SYDNEY WESTERN CITY PLANNING PANEL

REPORT: SWCPP Report

FILE No: DA 303.1/2022
PAN-441332
PPSSWC-281

Property:	Lot 1 DP 1302529 at No. 2 Kamira Court, Villawood
Application lodged	10 th October 2022
Applicant	Adam Byrnes (Think Planners)
Owner	NSW Land and Housing Corporation
Application No.	DA 303.1/2022
NSW Planning Portal Application No.	PAN-441332
Planning Panel Reference No.	PPSSWC-281
Proposed Development	Stage 2 of the Redevelopment of No. 2 Kamira Court within the Villawood Town Centre comprising a combination of 8-11 storey Mixed Use buildings containing a total of 228 residential units, a community facility, supermarket, retail premises, medical centre, associated landscaping and road works, car parking located with a basement and above ground (levels 1 and 2) and 2000m ² of public open space.
Cost of Works	\$81,140,147.00
Zoning	R4 High Residential under the Fairfield LEP 2013
Primary Planning Issues	<ul style="list-style-type: none"> • Above Ground Car Parking • Number of social housing units provided • Design Excellence • Potential Impact to Local Road system • Car Parking and Operational Details • Waste management matters

The submitted Clause 4.6 variation indicates the following breaches with Building A:

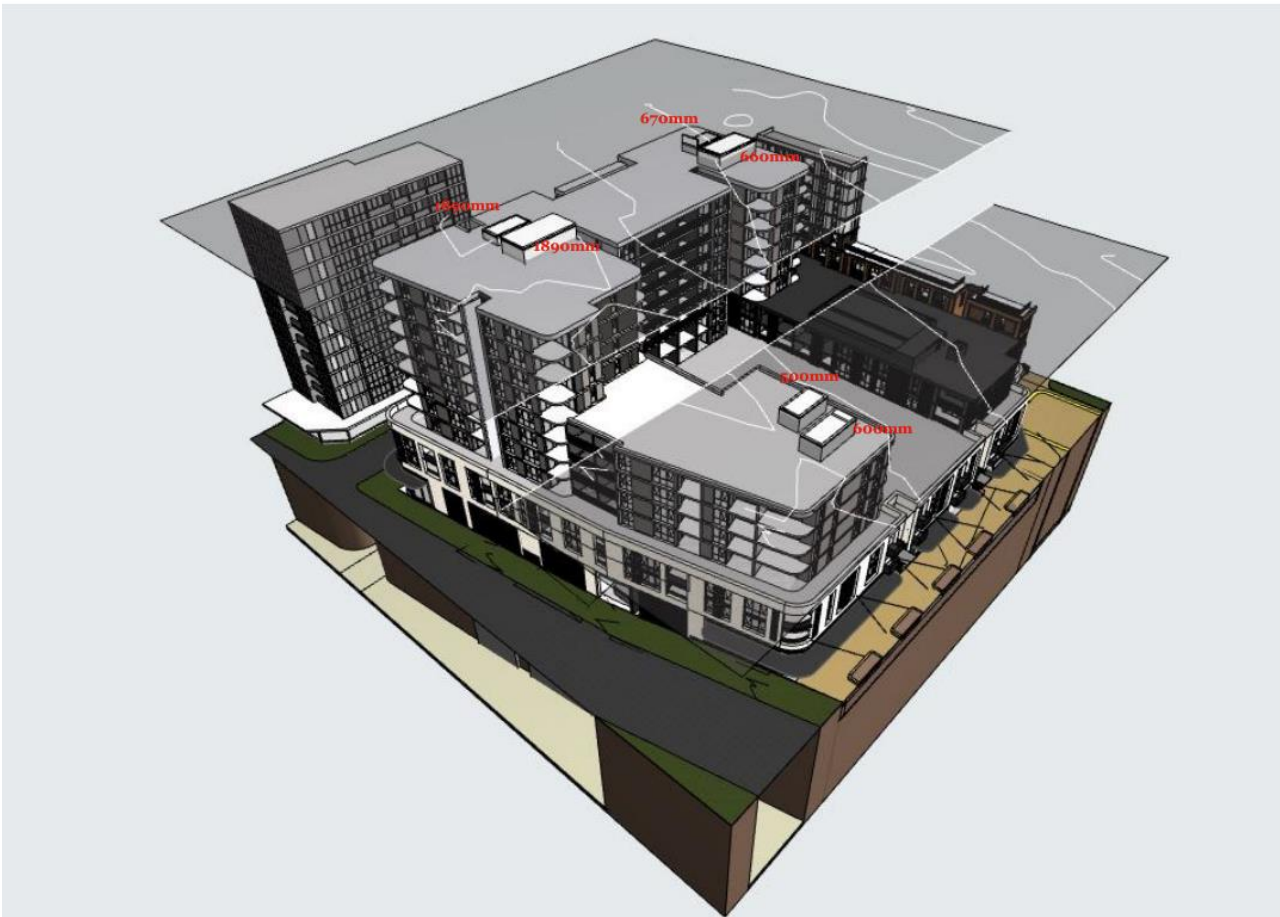
<i>Portion</i>	<i>Maximum Height</i>	<i>Departure</i>
Lift overrun	27.6m to the 27m height provision	600mm or 2.2% variation
	40.89 to the 39m height provision	1890mm or 4.8% variation

Above Ground Car Parking

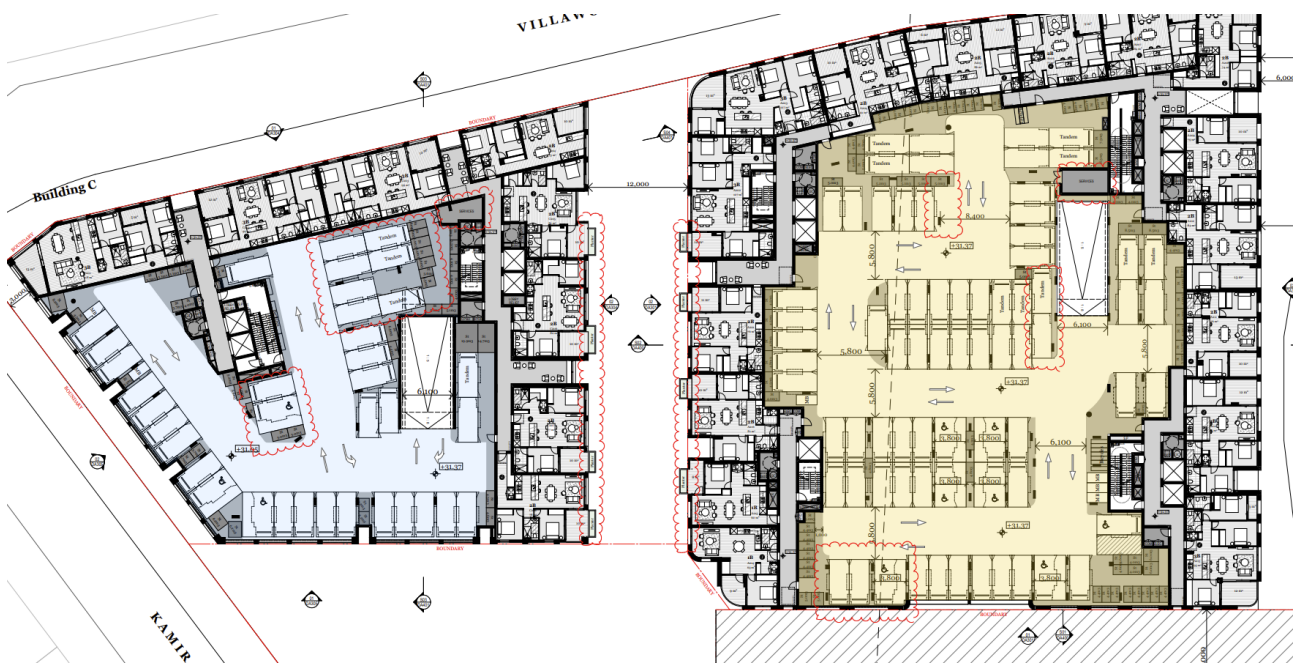
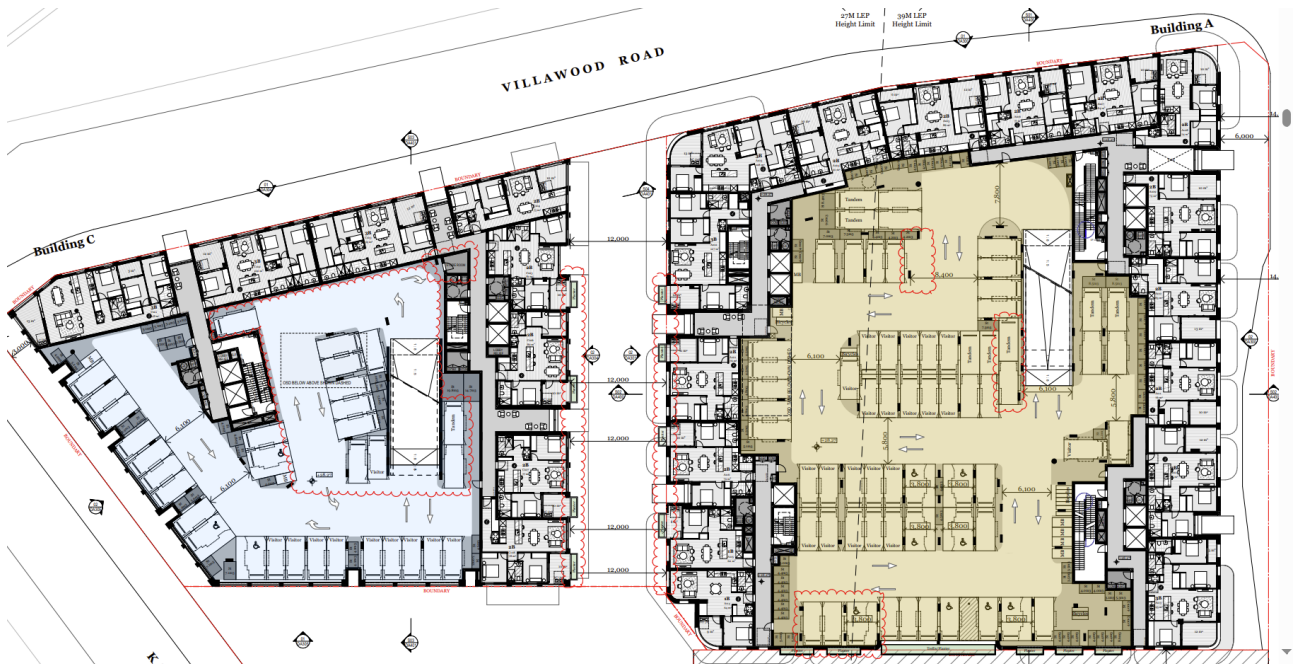
The application in its current form involves the provision of car parking in a podium arrangement, which is considered an inappropriate arrangement. This arrangement results in design issues which has effectively locked many uses into internalised spaces without access to natural light ventilation or outlook. It has also created an access system to the apartments which is excessively long, dog legged and without adequate relief from natural light. There are lost opportunities to provide high quality apartments and position back of house areas in inconspicuous areas. If further basement car parking was provided then further GFA could be provided. In the redevelopment of Villawood Town Centre, there has been three (3) recent large mixed-use developments that have been approved all with basement car parking and no above ground car parking. No 1 Villawood that is adjacent to the

Location of three (3) vehicle crossings and two (2) loading bays along the Villawood frontage.

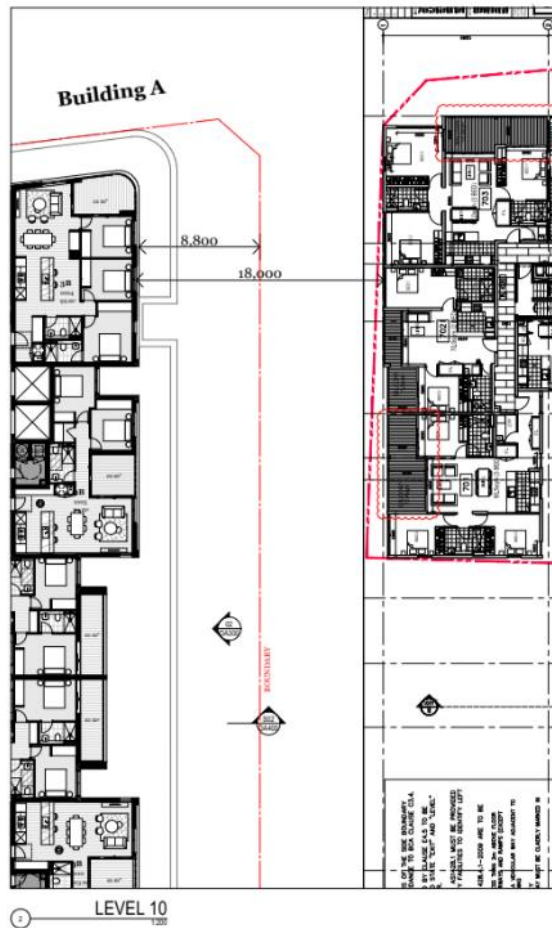
The presentation to Villawood Road has been designed to include major truck, delivery, car access driveways and services which effectively locks in this corridor as a secondary pedestrian zone and negatively impacts on the development of an appropriate street /precinct character. It is noted that some vehicle access at grade is necessary, however it is considered a reasonable expectation that the carparking, with very limited exceptions, should be below ground in any new development across Sydney. It is also arguable that loading docks for retail should also be below grade with lifts, as this is a very well tested approach, in denser living/retail environments.

The current design does not provide an appropriate balance of the competing issues of the location of servicing elements when assessed against the amenity and character objectives. It is considered that some rebalance be sought within the design to ground level Building A and C to remove or reduce extensive loading docks and entries from Villawood Road. The current design has more than 60% of the Villawood Road frontage as service or vehicle entries, and at very high level/scale to underside of awnings which severely impacts upon the quality of the pedestrian scale to Villawood Road.

An image from a response from the Applicant, which shows the separate distances between the eastern edge of the upper levels of Building A from the existing development at No. 1 Villawood Place.

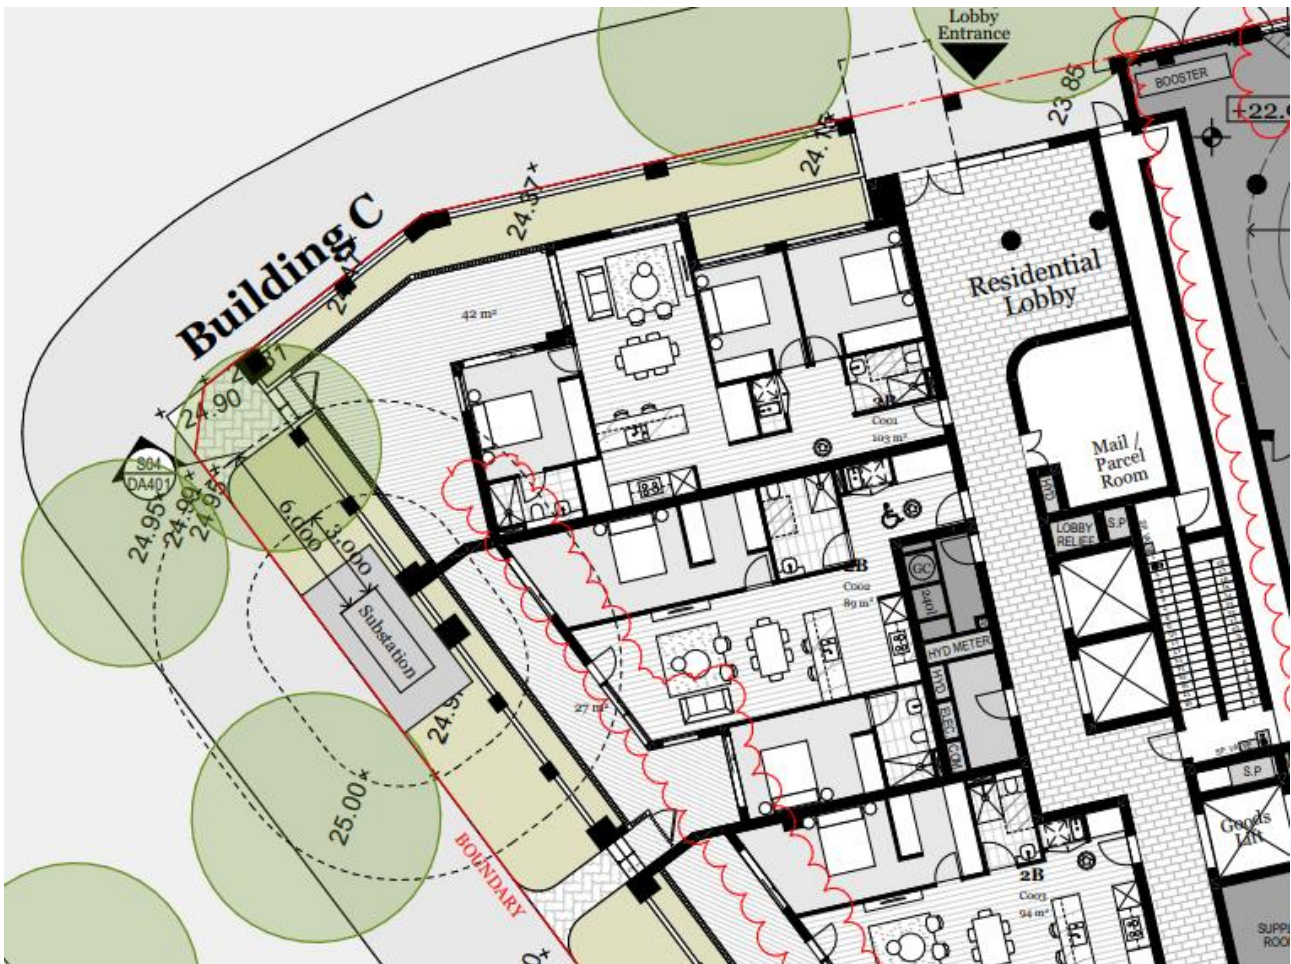
It is noted that the separation distances as required by the apartment Design guidelines between Tower A and existing the existing building at No. 1 Villawood Place do not strictly comply. The east corner of Building A tower does not comply for level 8, 9 and 10 as 24 metre separation between tower forms and habitable areas including balconies is required to meet the ADG. It is noted that in this distance 18m is provided at these levels.
